APPEAL SUMMARY

Appeal ID: 24641	Project Address: 1221 SW 12th Ave
Hearing Date: 2/24/21	Appellant Name: Joshua Klyber
Case No.: B-006	Appellant Phone: 5032091458
Appeal Type: Building	Plans Examiner/Inspector: John Cooley
Project Type: commercial	Stories: 2 Occupancy: B, E, S-2 Construction Type: II-B
Building/Business Name: Northwest Academy - Plaza Building	Fire Sprinklers: Yes - Throughout proposed
Appeal Involves: Alteration of an existing structure, Reconsideration of appeal	LUR or Permit Application No.:
Plan Submitted Option: pdf [File 1] [File 2] [File 3]	Proposed use: Education Facility

Code Section 24.85.040 (A) & (B) Change of Occupancy or Use.

CENTURY BUILDING SECOND FLOOR TI

1 FLOOR PLAN
 SCALE 1/8" = 1'-0"

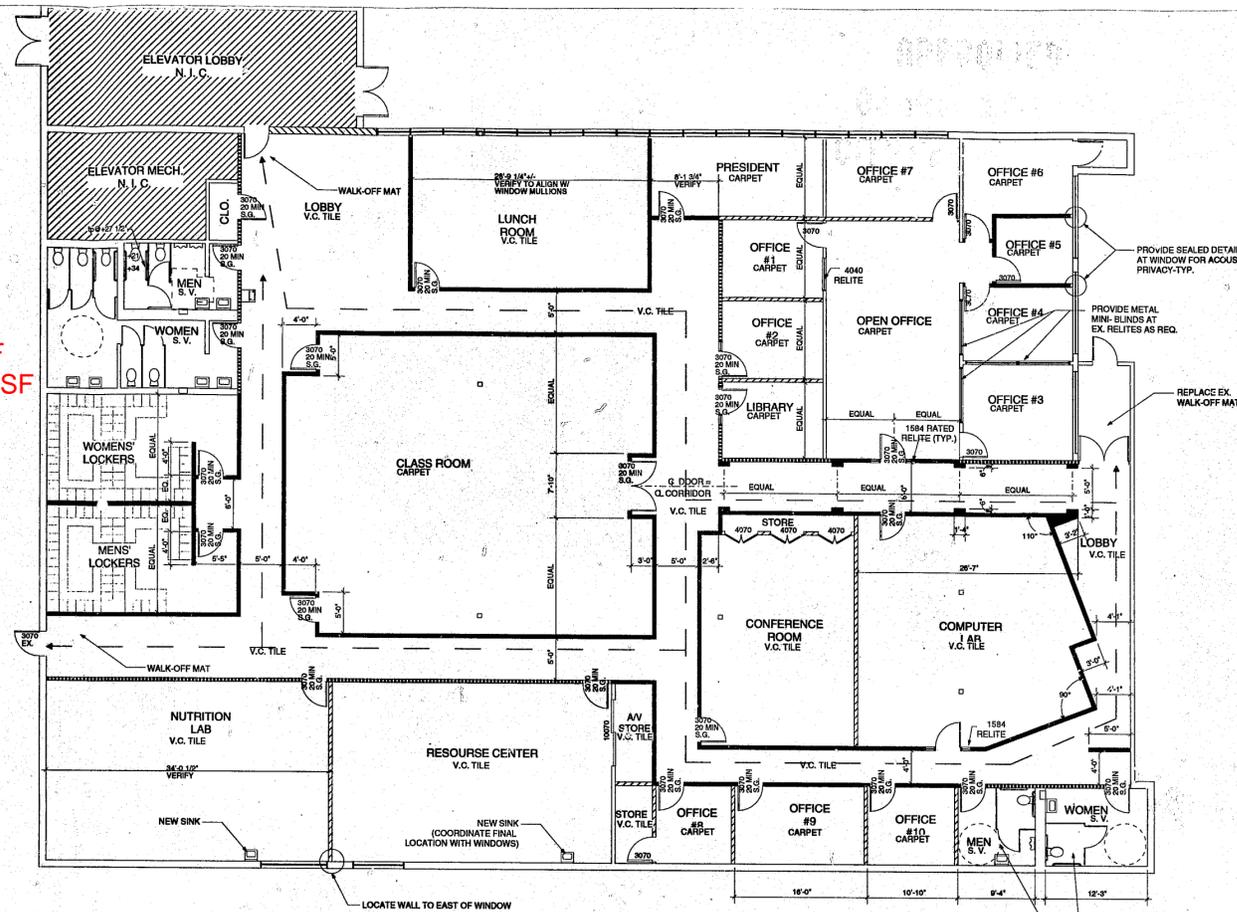
Calculation of occupant load of circulation space

Total net area = 4458 SF
 Total gross area = 4568 SF
 Net area = 49% of total area
 Gross area = 51% of total area

Circulation Space = 2970 SF
 Net Circulation Space = 1455 SF
 Gross Circulation Space = 1515 SF

2004 BASELINE OCCUPANT LOAD ANALYSIS WAS RECALCULATED BASED ON THIS INFORMATION, USING ACCURATE OLF AND OCCUPANT ANALYSIS METHOD TO INCLUDE CORRIDORS AS PART OF THE GROSS CALCULATION.
